ADDENDUM NO. 01

RANKIN TRAILS AMPHITHEATER AND BASEBALL PARK

Rankin County, Mississippi

WBA Proj. # 2215/2315

S1.1
FOUNDATION PLAN

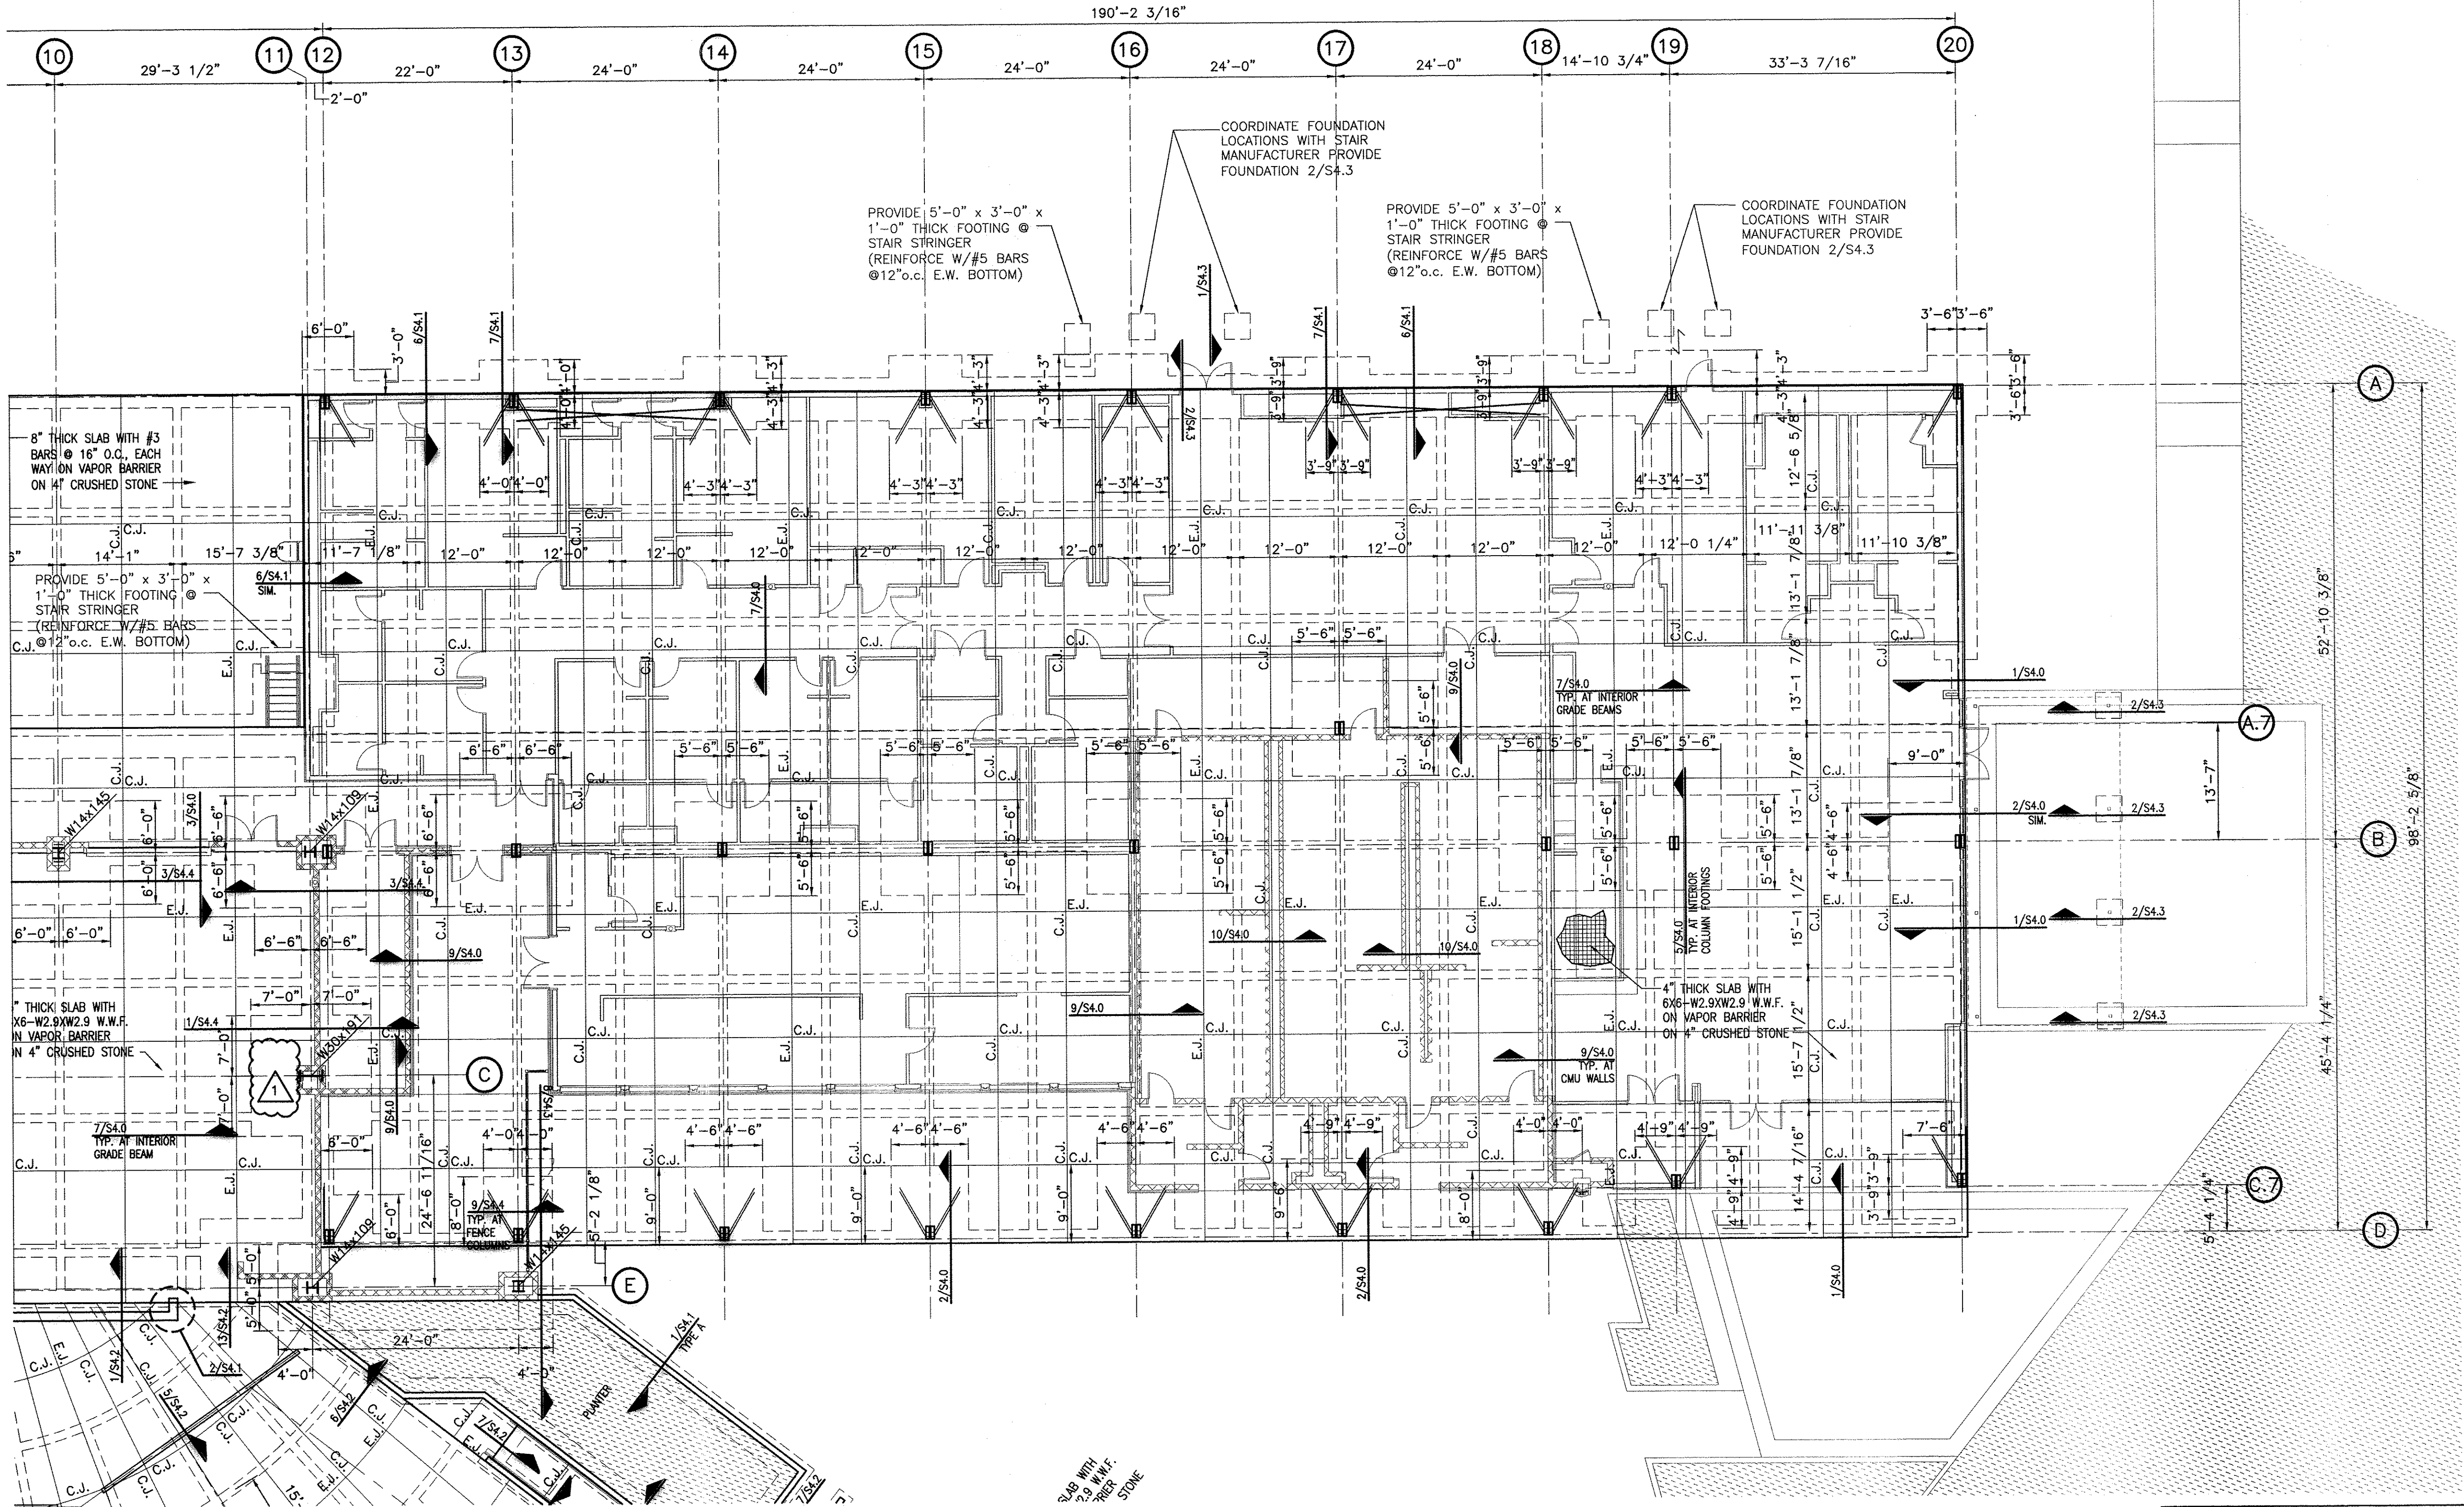
- ITEM NO. 11** **SHEET S1.1 FOUNDATION PLAN**
REMOVE stray column, per enclosed revised sheet S1.1.
- ITEM NO. 12** **SHEET S1.2 FOUNDATION PLAN**
REMOVE stray column, per enclosed revised sheet S1.2.
REVISE control joints, per enclosed revised sheet S1.2.

S2.1

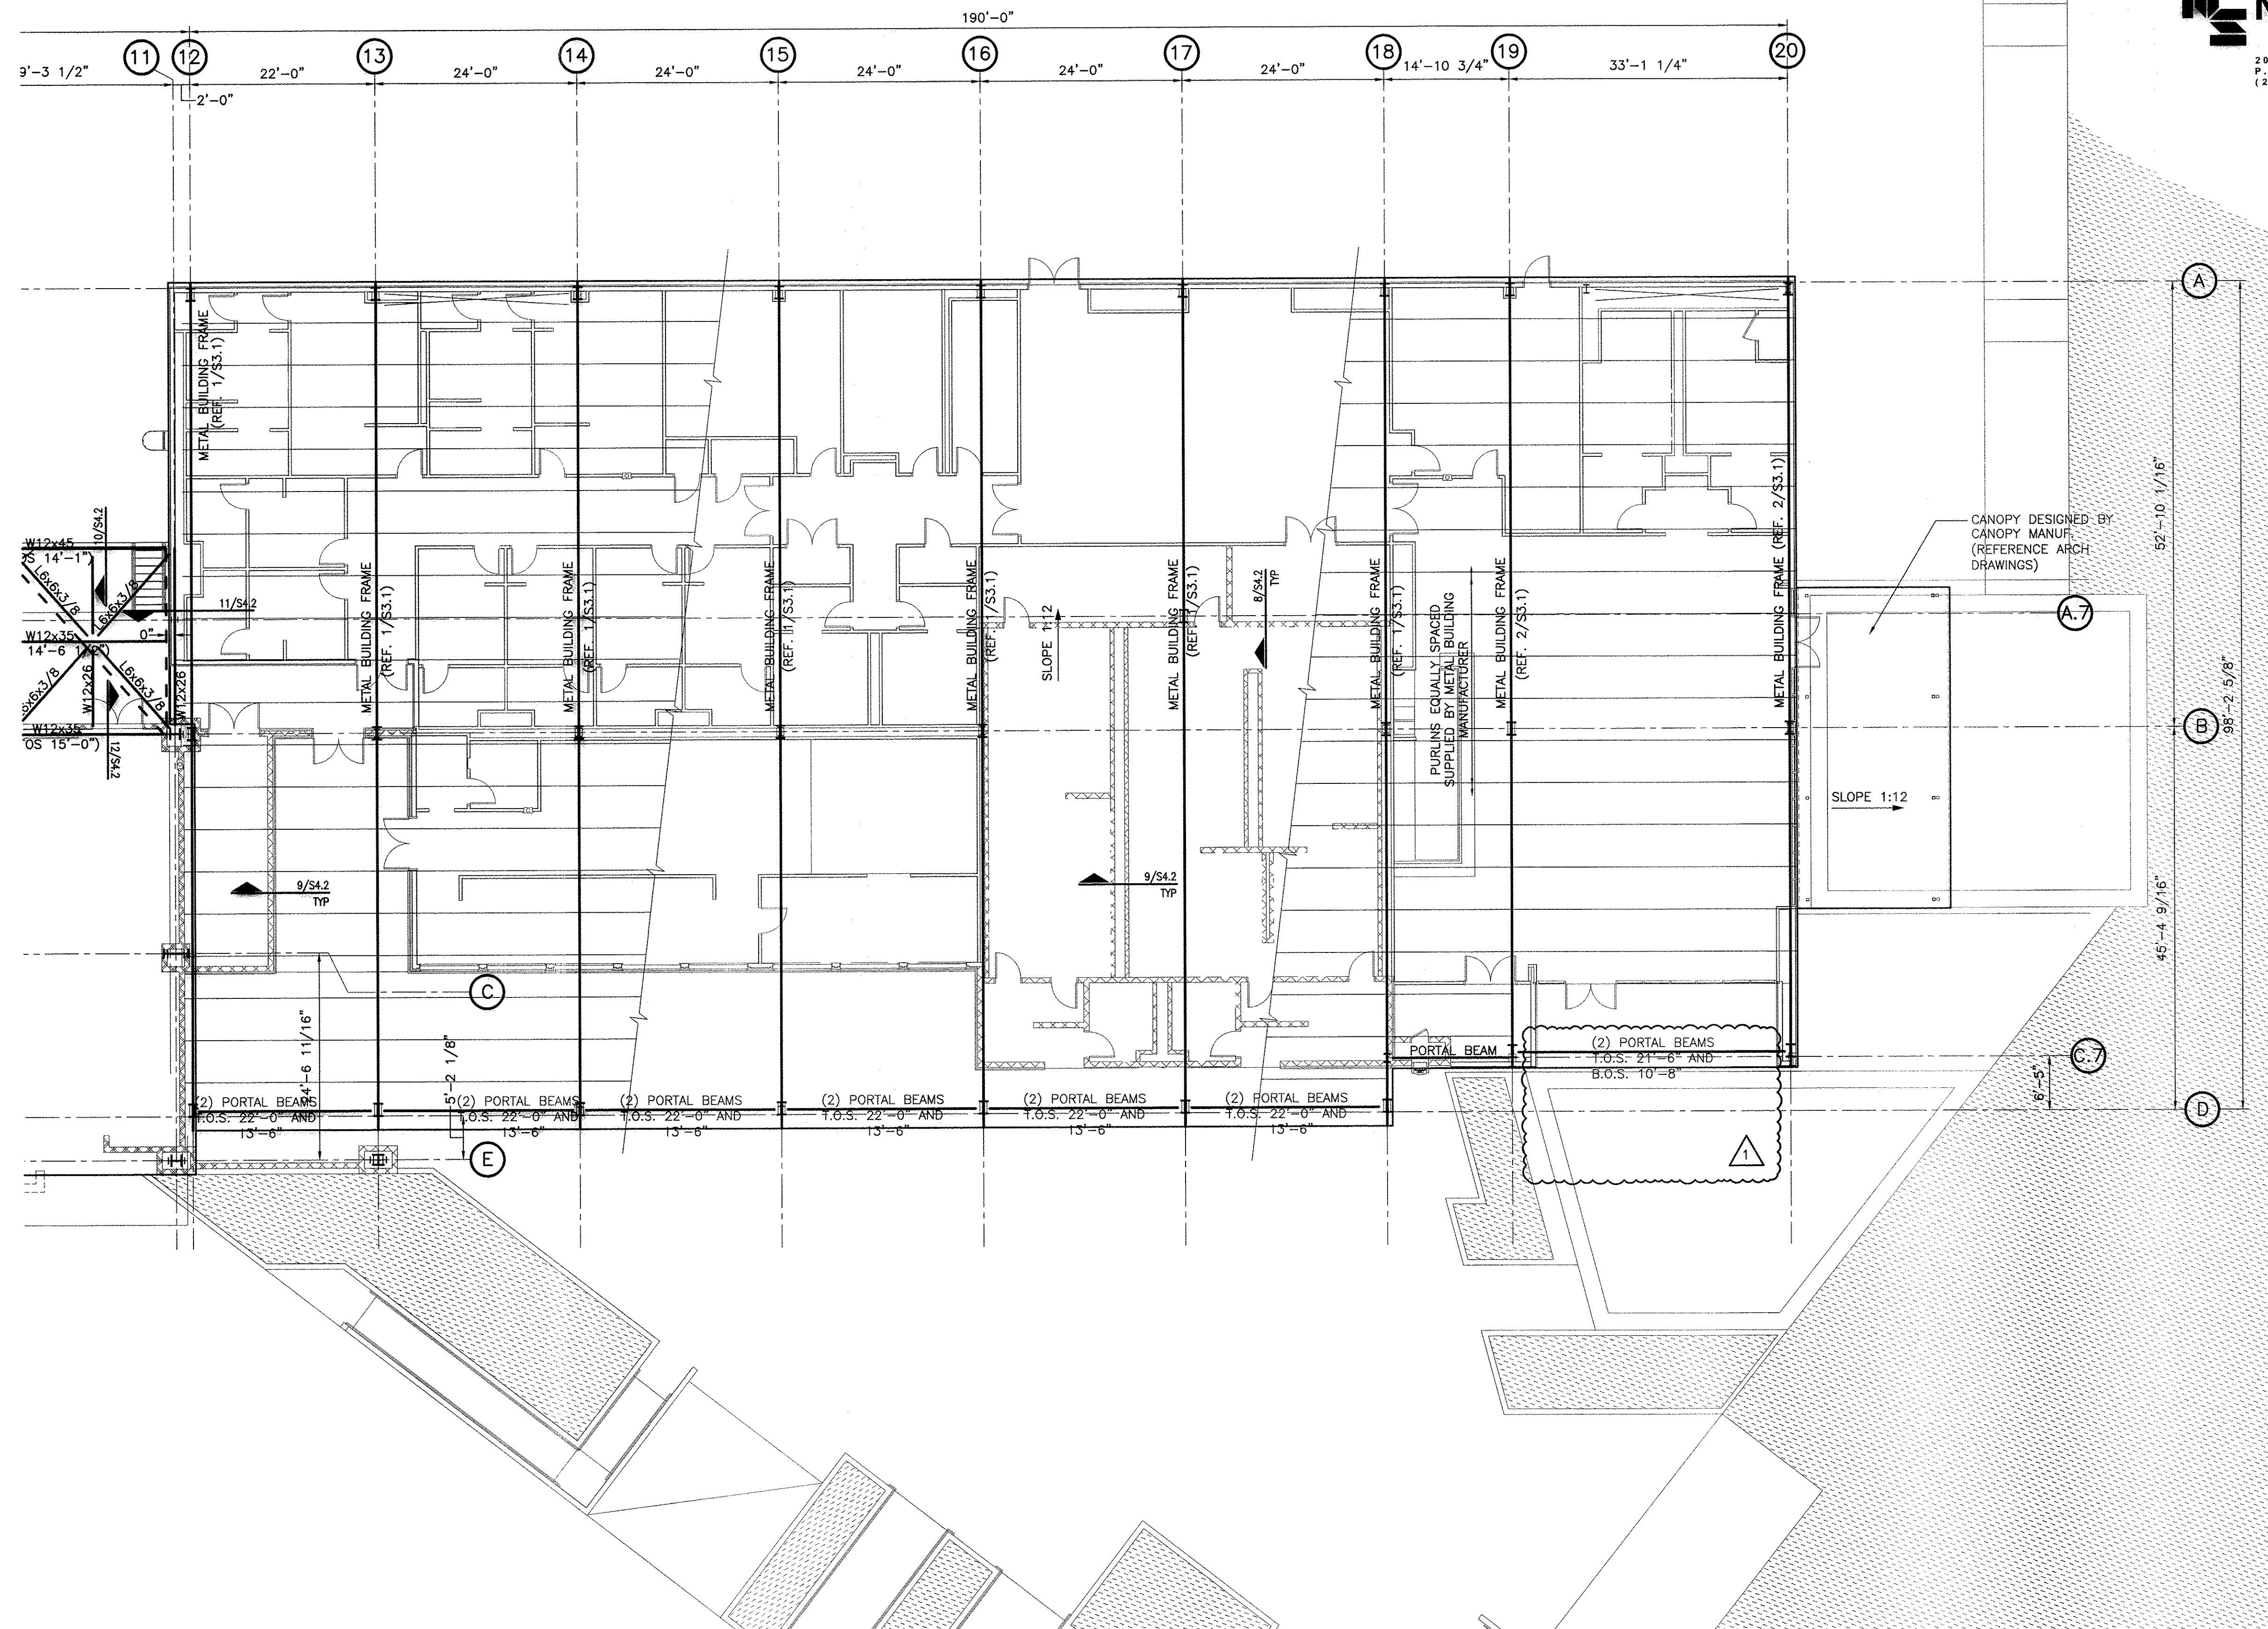
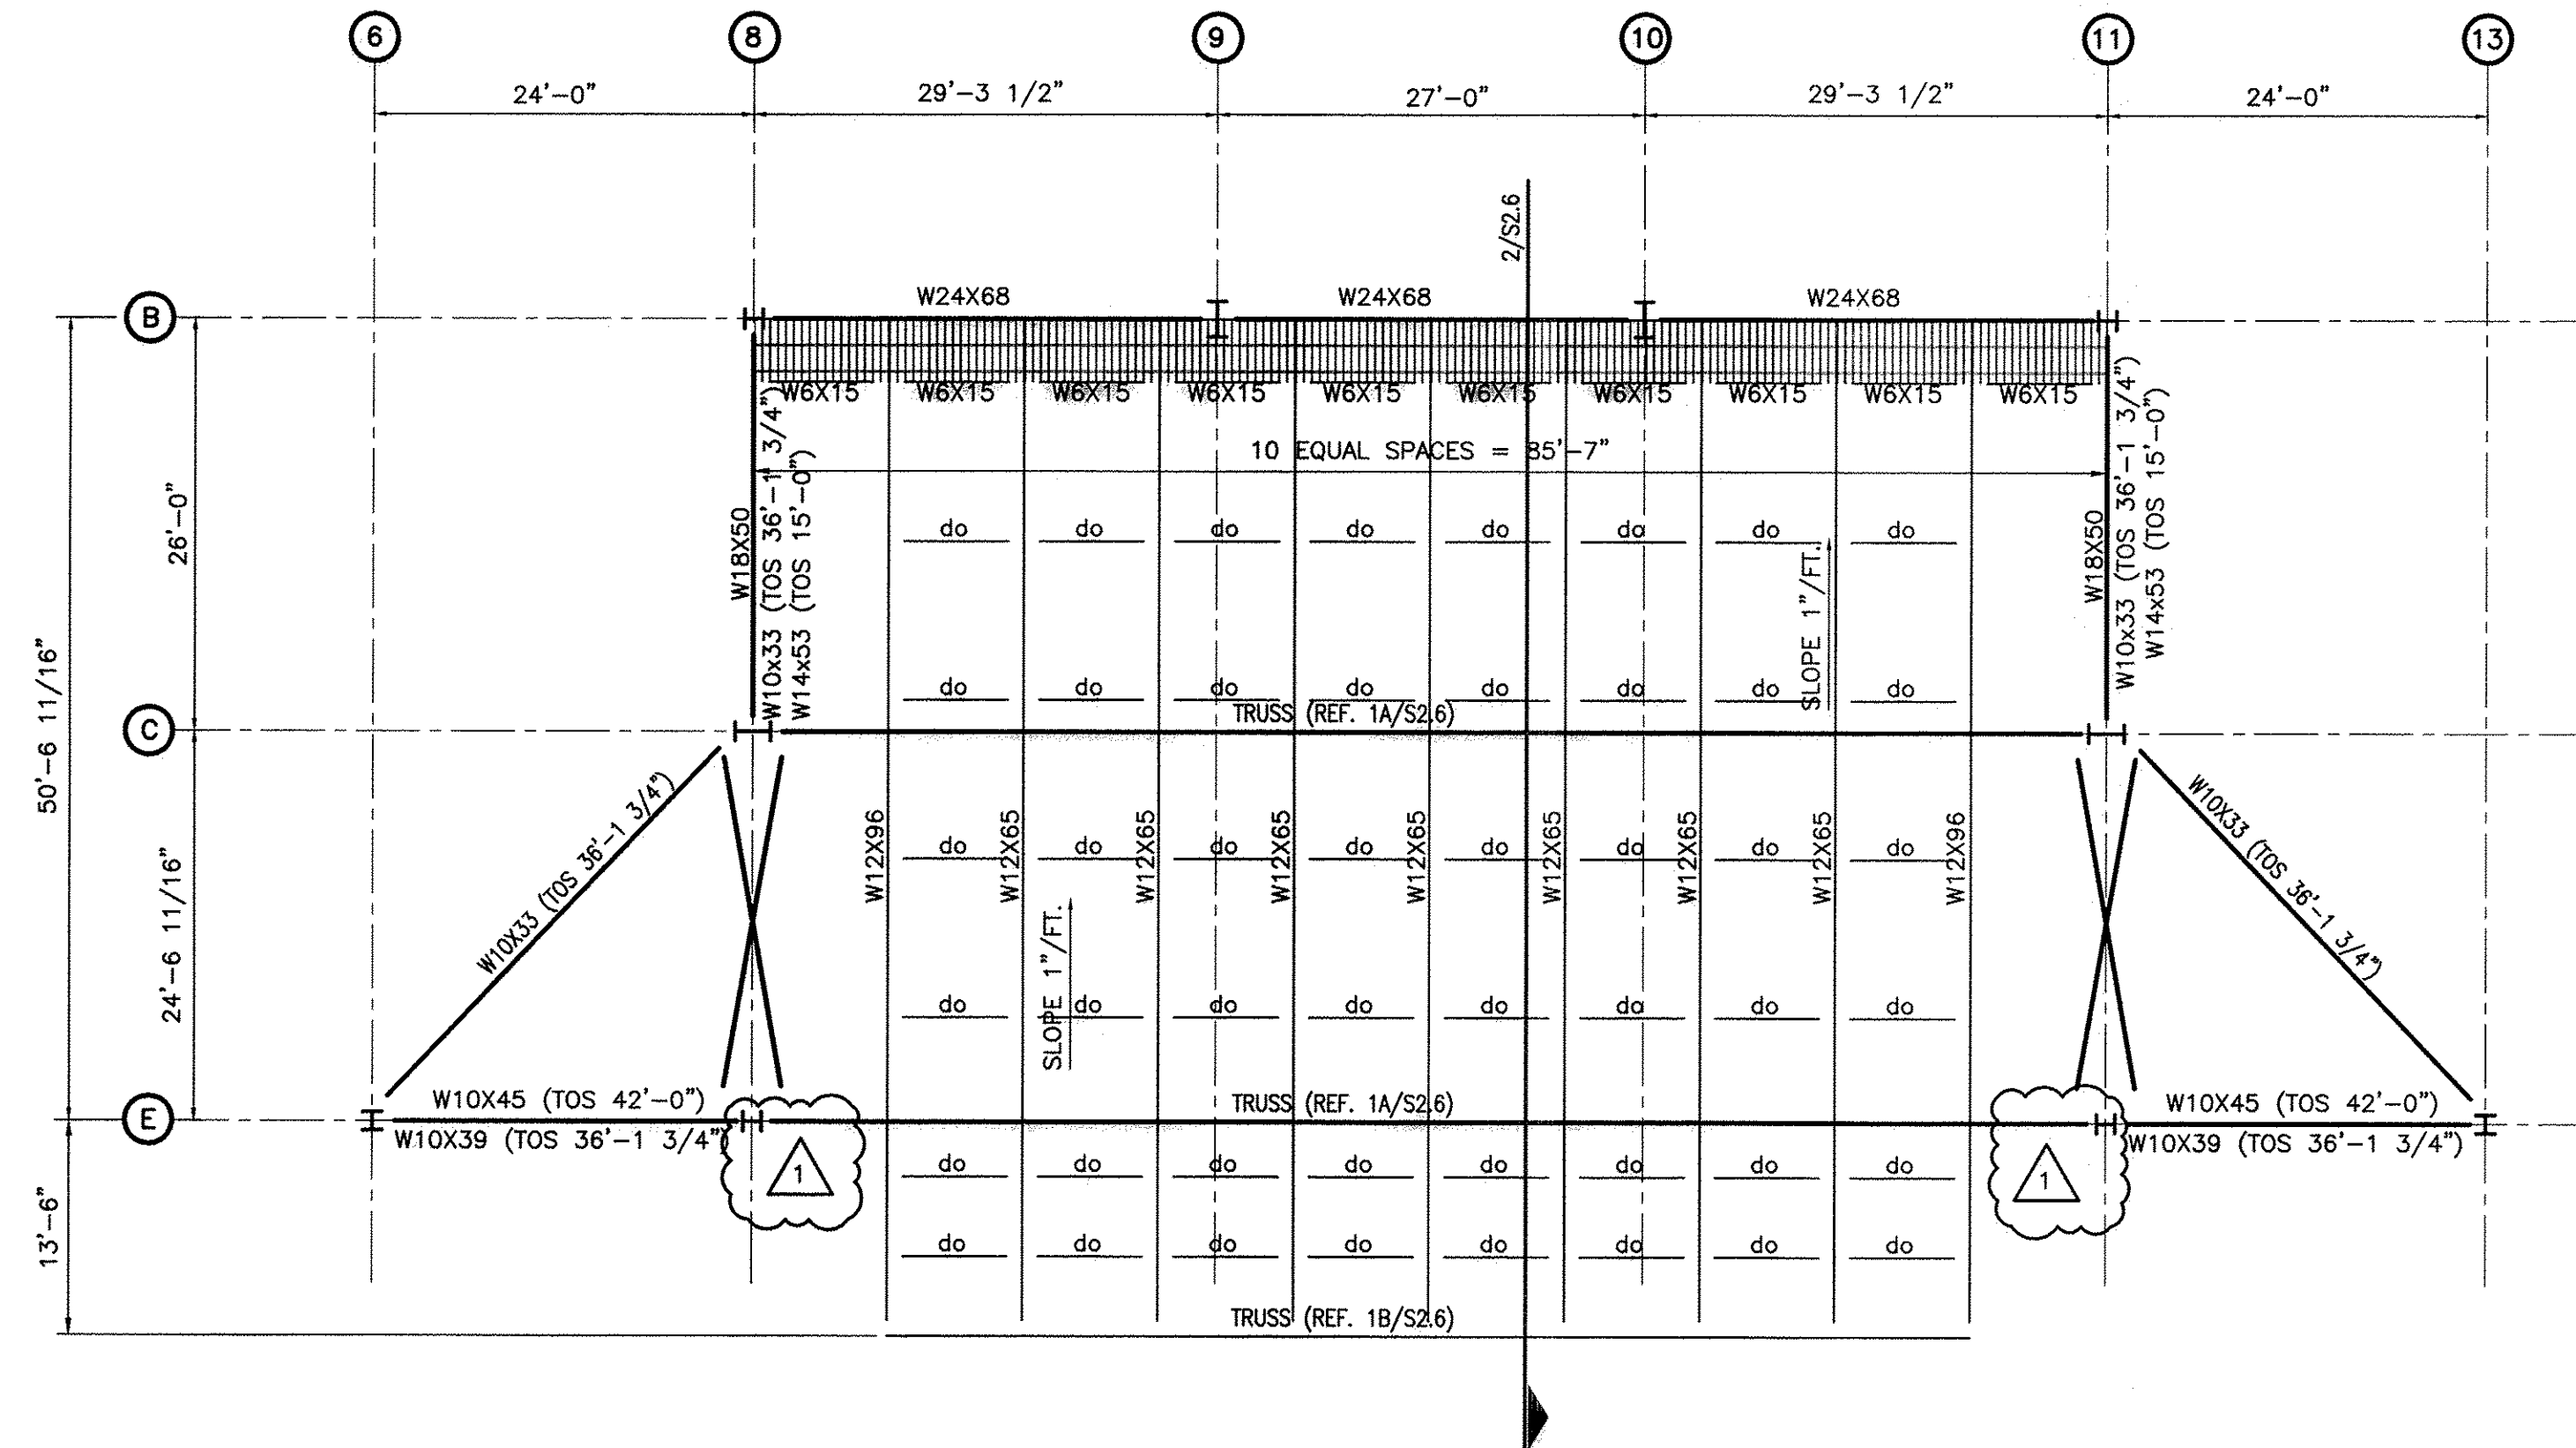
- ITEM NO. 13** **SHEET S2.1 ROOF FRAMING PLAN**
REVISE portal beam dimension change to Bottom of Steel 10'-8" above finish floor on column line C.7, per enclosed revised sheet S2.1.
